**PERMIT ISSUED**  
 Permit Number: 051813  
**FEB - 7 2006**  
**CITY OF PORTLAND**

This is to certify that BRADCO REALTY CORP M Construction Co.  
 has permission to Construct new 31,000 Sq Ft al build for additional stor of building materials  
 AT 238 RIVERSIDE ST L 316 B0200

**Supplemental Submittal  
Wickes Lumber/BRADCO Supply Site Plan Review**

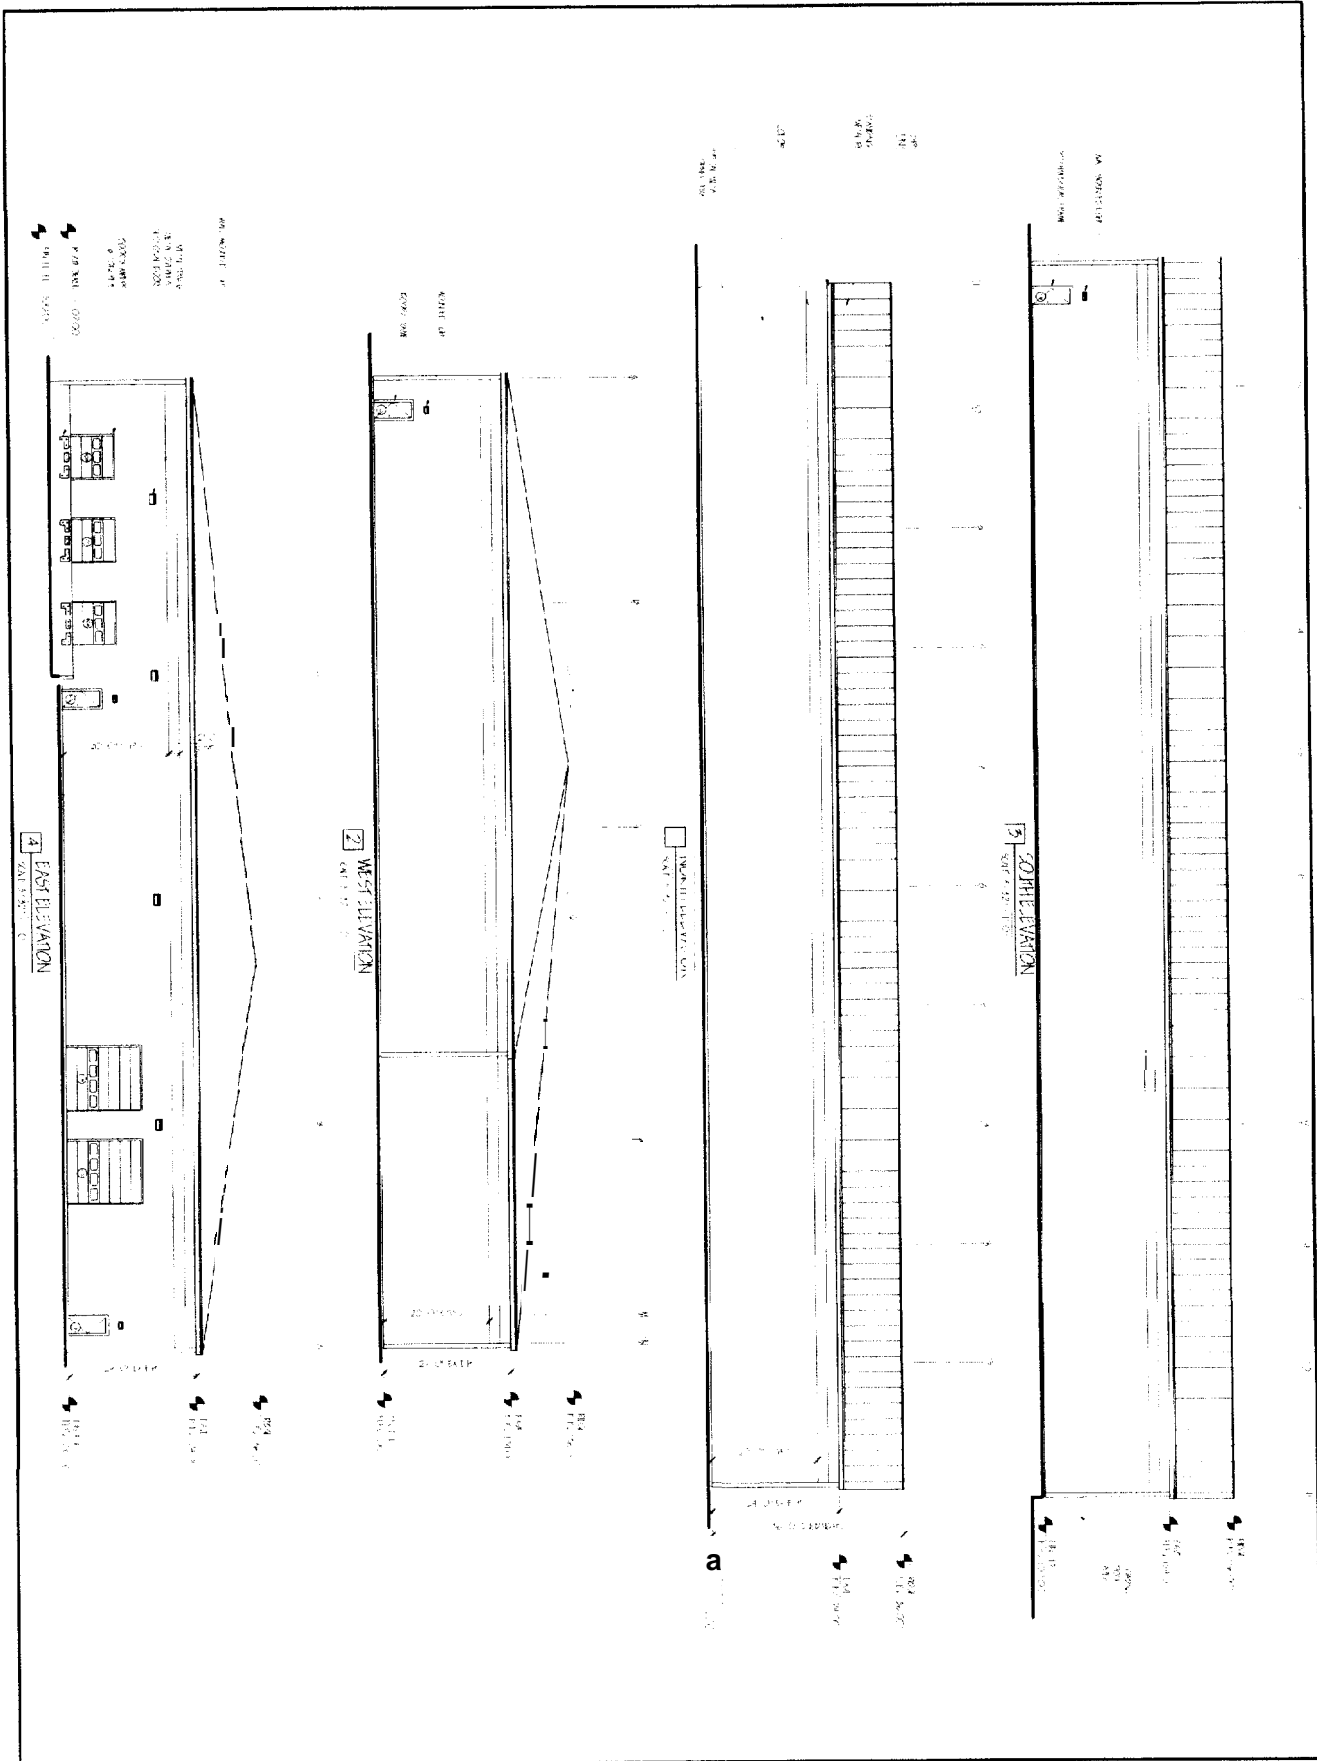
I have spoken to Stephen Doe concerning a readable elevation plan to determine compliance. He has e-mailed me a readable copy of the building elevation which shows that the building height is well the maximum allowed.
